KENWOOD

ASB-1053

Service Bulletin

Subject: TS-950SDX Change of Gate Resistor Type **Date:** March 28, 1994

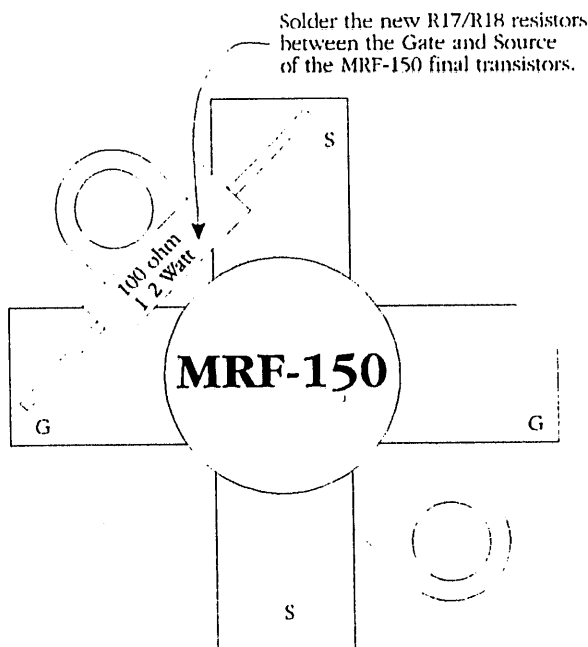
If the final amplifier is operated at excessive transmit levels (over 150 watts output) the final FET's may fail and short from Source to Gate. If this occurs, the bias resistors used in this circuit may be damaged and cause a large amount of smoke to be emitted from the final compartment.

Change the carbon type resistors used for R17 and R18 to the fuse type resistors specified below. This will prevent an unpleasant odor and smoke from the final compartment.

Remove the old resistors from their locations on the circuit board and install the new resistors directly between the Gate and Source of the final transistors. (See the illustration below.)

Qty	Description	New Part No.	Circuit Description
2	100 ohm 1/2 watt Fuse Resistors	R92-1310-05	R17, R18
